Temakaw Fashion Ltd KAW Garments Industry Ltd

06 May 2014

Observations

Steel Roof Structures

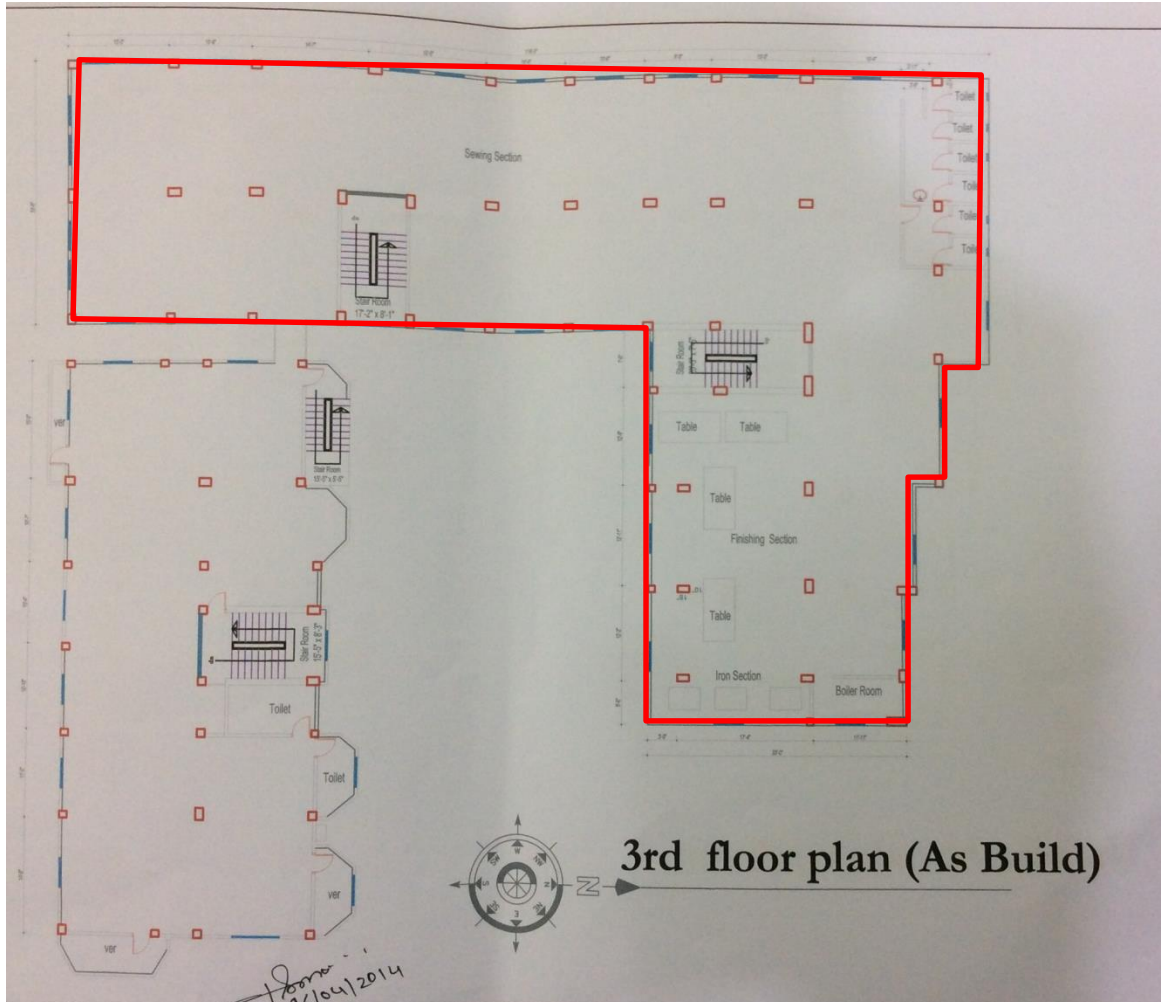
Structural adequacy of steel roof structures

Building Engineer to check adequacy of the steel roof structure for code specified live load and wind loads

Typical column layout

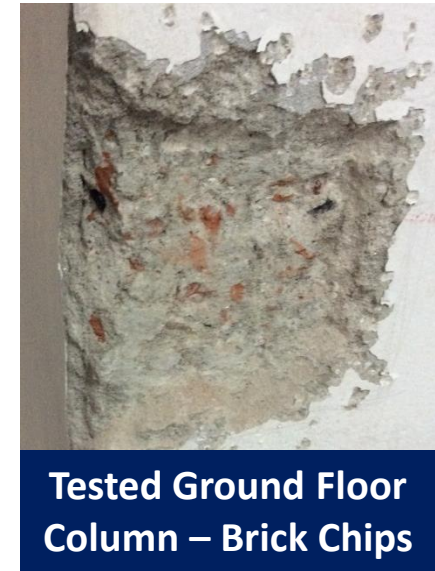
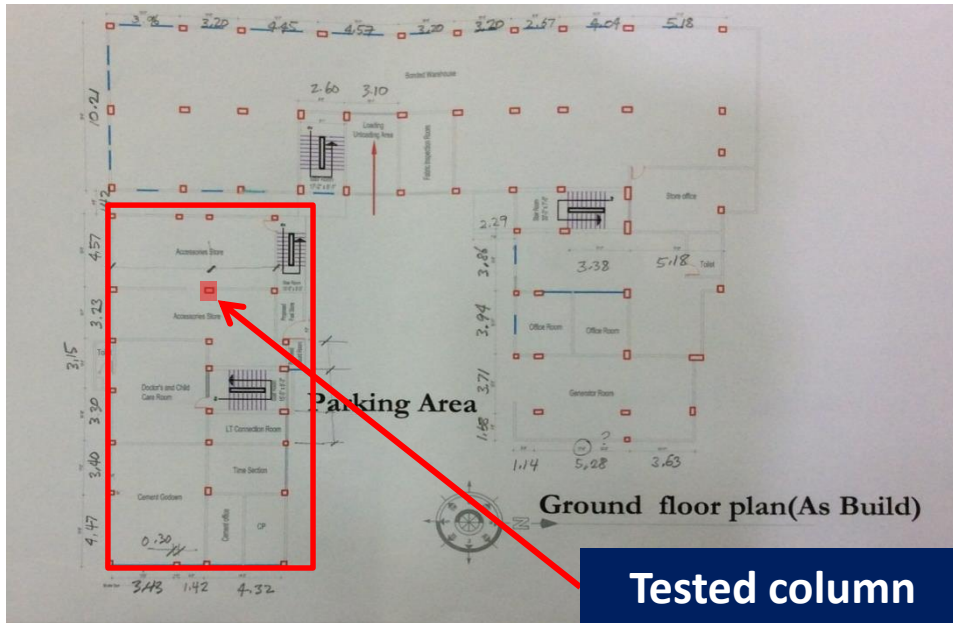
**Columns appear to be stressed in
excess of normal design limits**

Cursory calculations indicate that columns are stressed in excess of normal design limits and require review.

Building Engineer to review design, loads and column stresses of columns and conduct concrete tests to prove adequacy of all column sizes, and (if required):

- Reduce loads by vacating floors
- Reinforce columns

Steel Roof Structures

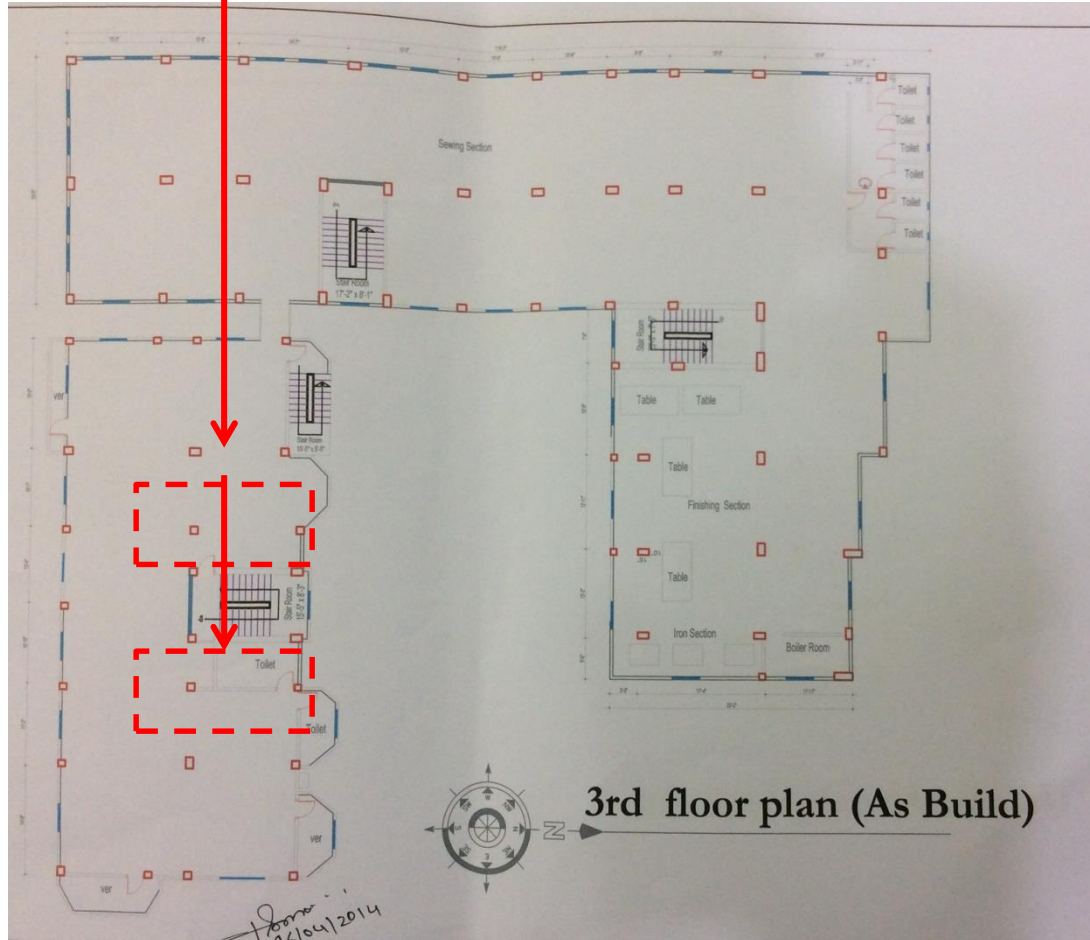
Structural adequacy of steel roof structures

**Building Engineer to
check adequacy of the
steel roof structure for
code specified live load
and wind loads**
